SUBJECT: ISSUANCE OF AMENDMENT NO. 68 TO FACILITY OPERATING LICENSE NO. NPF-63 REGARDING CHEMISTRY DATA CHANGES FOR TS FIGURES 3.4-2, AND 3.4-3  
- SHEARON HARRIS NUCLEAR POWER PLANT, UNIT 1 (TAC NO. M97542)

SHEARON HARRIS NUCLEAR POWER PLANT, UNIT 1

Amendment No. 68  
License No. NPF-63

SAFETY EVALUATION BY THE OFFICE OF NUCLEAR REACTOR REGULATION

FIGURE 3.4-2

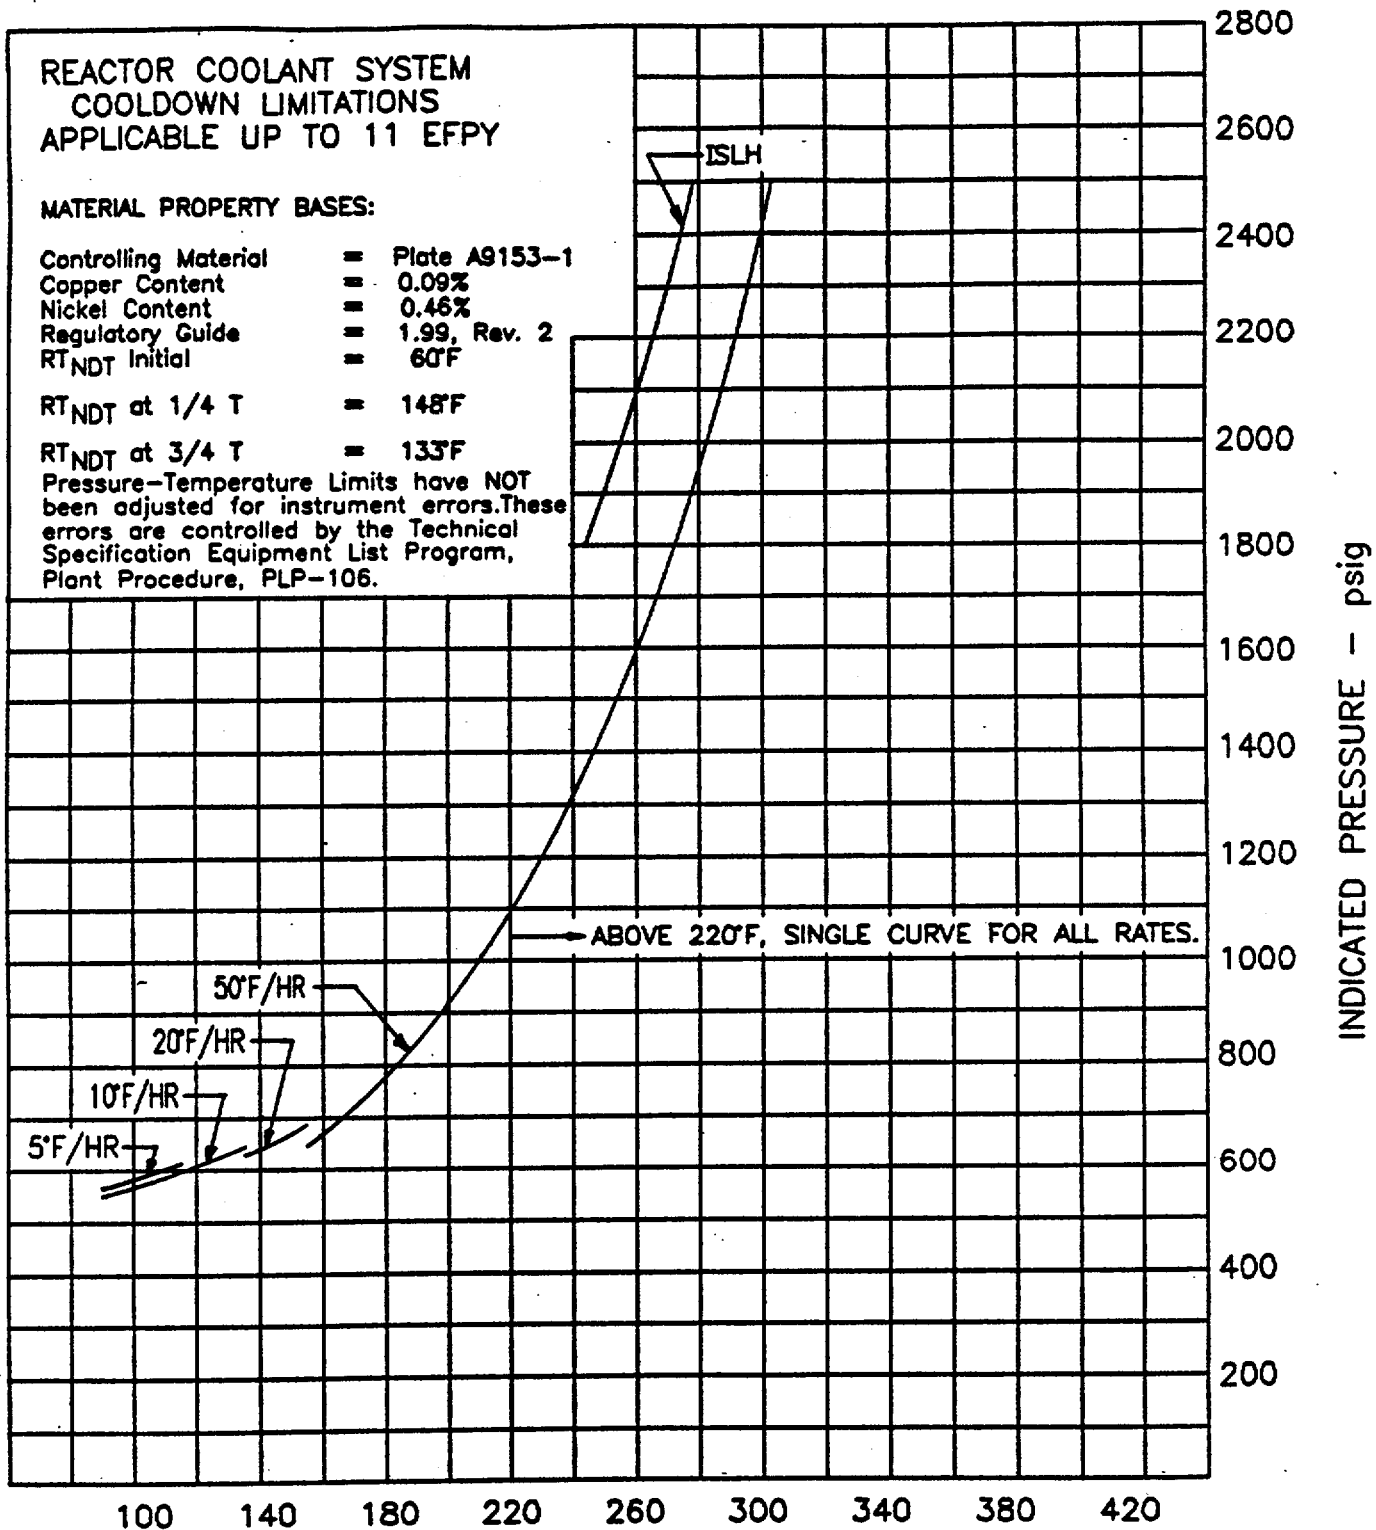
The amendment revises chemistry data shown on TS Figures 3.4-2 and 3.4-3 for the Reactor Coolant System's Pressure/Temperature Limits and the associated Bases.

By letter dated December 30, 1996, the Carolina Power & Light Company (the licensee) submitted a request for changes to the Shearon Harris Nuclear Power Plant, Unit 1 (SHNPP), Technical Specifications (TS). The requested changes would revise (1) chemistry data shown on TS Figures 3.4-2 and 3.4-3 for TS 3/4.4.9, "Pressure/Temperature Limits" and (2) its associated Bases.

In the December 30, 1996, submittal, the licensee submitted slight changes to some of the best estimate chemistry values for the beltline materials. These changes resulted from cooperative data sharing activities in response to Generic Letter (GL) 92-01, Revision 1, Supplement 1. Specifically, the licensee reviewed available reactor pressure vessel (RPV) beltline material data, and identified plants that have the same weld heat identifications as those contained in the Harris vessel (sister plants). In addition to sharing data with sister plants, the licensee also shared data with the Westinghouse Owners Group (WOG) in order to determine best estimate chemistry for the beltline materials. As a result of these assessments, the nickel content of the limiting material increased from 0.45% to 0.46%. This slight change in nickel content does not affect the pressure-temperature (P-T) limits in the SHNPP TS. However, some documentation changes in TS Figures 3.4-2 and 3.4-3 are necessary. The amendment request also revises the associated Bases to reflect chemistry revisions and minor material property changes for the beltline weld fabricated from weld wire heat 5P6771. In addition, the licensee submitted revisions to the Bases in order to comply with 10 CFR 50, Appendix G rule changes.

**MATERIAL PROPERTY BASES:**

Controlling Material = Plate A9153-1  
Copper Content = 0.09%  
Nickel Content = 0.46%  
Regulatory Guide = 1.99, Rev. 2  
RT NDT Initial = 80°F

RT NDT at 1/4 T = 145°F

RT NDT at 3/4 T = 133°F

The limiting material in the Shearon Harris reactor vessel is the intermediate shell plate that was fabricated using heat number A9153-1. The licensee determined that the slight increase in the nickel content of the limiting material from 0.45% to 0.46% did not affect the P-T limits. The staff performed independent calculations of the CF values for the beltline materials using the revised best estimate chemistry and the methodology in RG 1.99, Revision 2. Based on these calculations, the staff verified that the CF of the limiting material remained unchanged. Since the revised best estimate chemistry does not affect the limiting material, it will not affect the P-T limits. Therefore, Amendment 38 dated August 20, 1993, which approved the P-T limits curves to 11 effective full power years (EFPY), remains valid.
